UNITED STATES PATENT AND TRADEMARK OFFICE

APPLICATION NO.	FILING DATE	FIRST NAMED INVENTOR	ATTORNEY DOCKET NO.	CONFIRMATION NO.
10/726,656	12/04/2003	Sonny Lin	BHT-3125-175	5852

Office Action Summary	Application No. 10/726,656	Applicant(s) LIN, SONNY	
	Examiner Justin Krause	Art Unit 3682

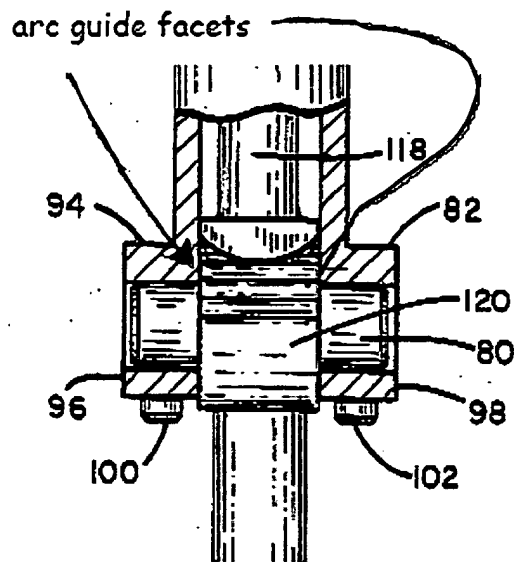
-The connector bar unit also including an inverted U-shaped limiting slot defining the lower section thereof, two pivoting plates extending downwards at both sides of the limiting slot thereof, and a pivoting pin hole disposed at the lower section of each

pivoting plate thereof for a pivot pin to be led and engaged therewith; the upper section of the limiting slot thereof having a securing plane disposed at one side thereon, an inner annular sleeve groove indented at one side of the securing plane thereon and an outer annular sleeve groove communicating with the inner annular sleeve groove via a step-wise through hole through which a screw bolt of a bottom quick-release unit is led there through to be registered with a lower screw nut; a retaining block, properly matched to the securing plane thereof, having a step-wise retaining hole disposed thereon for a spring element to be adapted therein, and an arc single direction retaining teeth facet defining the bottom side thereof;

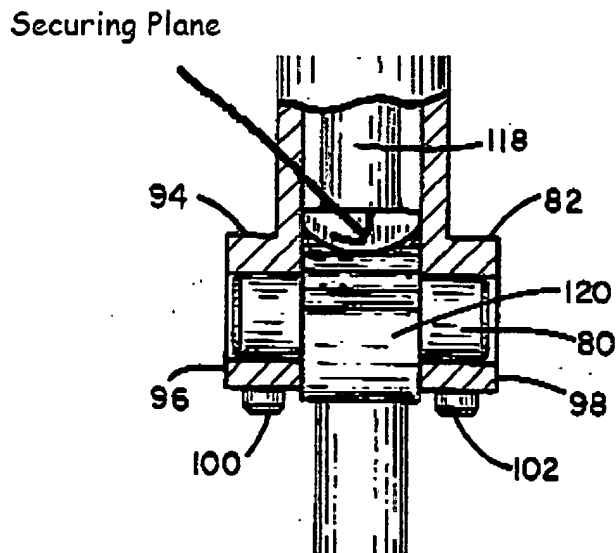
A front fork unit being made up of a coupling section protruding at the top thereof (120), two arc guide facets symmetrically indented at both lateral sides of the coupling section thereof,

an arc single direction adjusting teeth (124) face defining one top side of the coupling section thereof, and an axial through hole disposed at the middle section thereof.

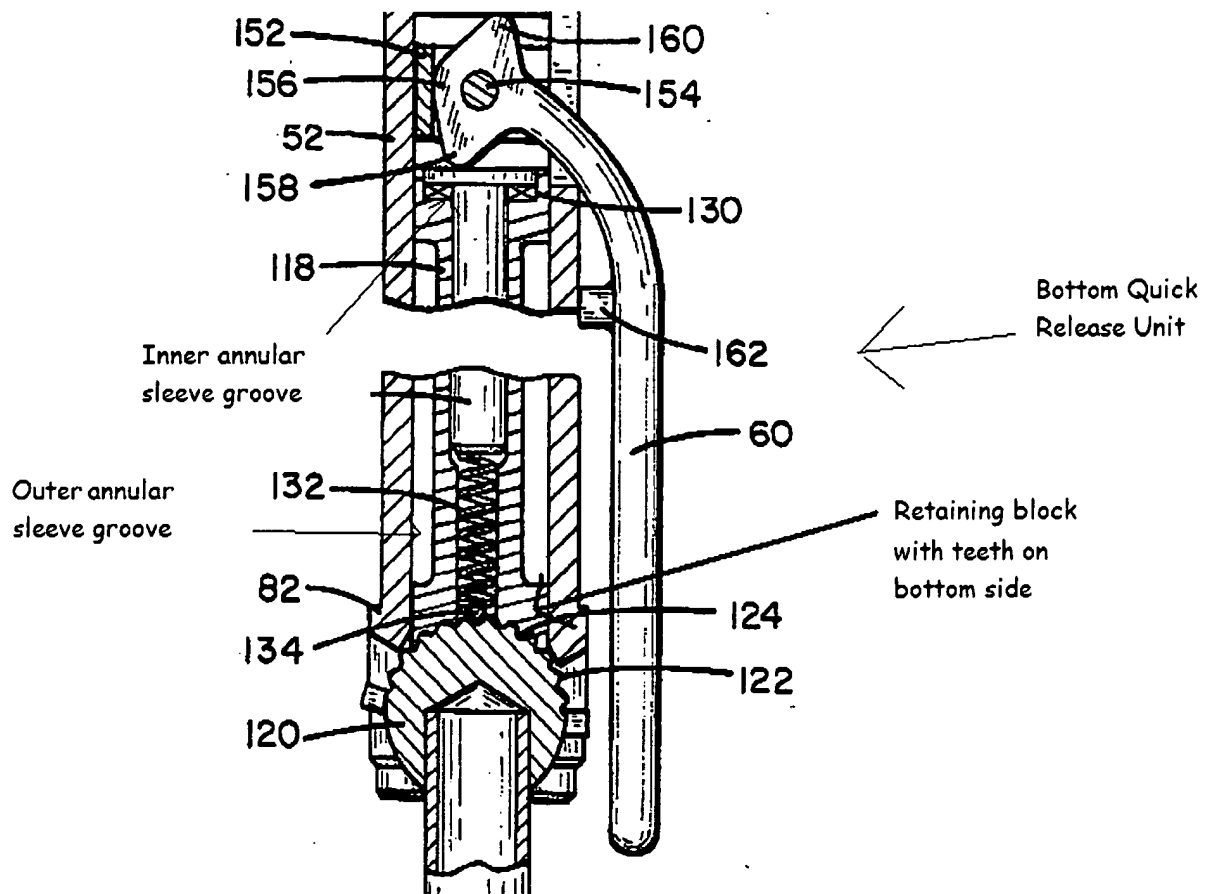
The connector bar unit also including an inverted U-shaped limiting slot (94 in combination with 96 and 98) defining the lower section thereof, two pivoting plates (94 and 98) extending downwards at both sides of the limiting slot thereof, and a pivoting pin hole (in 82) disposed at the lower section of each pivoting plate thereof for a pivot pin (80) to be led and engaged therewith; the upper section of the limiting slot thereof having a securing plane disposed at one side thereon

an inner annular sleeve groove indented at one side of the securing plane thereon and an outer annular sleeve groove communicating with the inner annular sleeve groove via a step-wise through hole through which a screw bolt (126) of a bottom quick-release unit is led there through to be registered with a lower screw nut; a retaining block, properly matched to the securing plane thereof, having a step-wise retaining hole disposed thereon for a spring element to be adapted therein, and an arc single direction retaining teeth facet defining the bottom side thereof for the purpose of locking the steering column members together (Col. 5, lines 49-53).

It would have been obvious to one having ordinary skill in the art at the time the invention was made to modify the teachings of Chou and incorporate the connector bar unit/front fork unit joint as taught by Marier for the purpose of locking the steering column members together. The device of Chou features a functionally equivalent structure (illustrated in Figs 8 and 9 of Chou).
